# APPLICATION

## SEWAGE DISPOSAL TESTING

RE: Resubdivision of Lot 4 -  
Justifiable

JUSTIFIABLE NEW Lot NEW 4

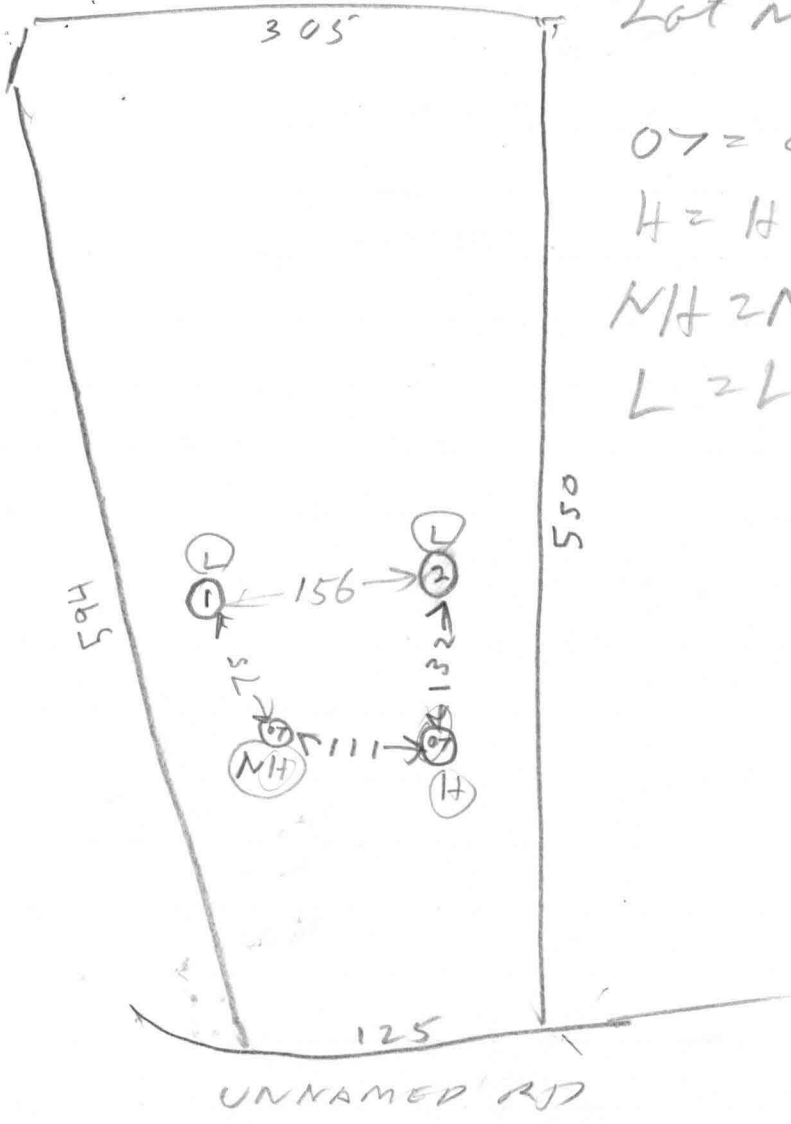
*S Kinser  
Certe  
sewage area  
shown  
wrong  
per  
test*

*RH Approve  
Moonfield*

*RH Approve  
Moonfield  
Spec DW  
12/14/77*

*11/17/78  
Consult with  
DM  
about spec*

*Water spec  
11/17/78 RH  
use for DW*
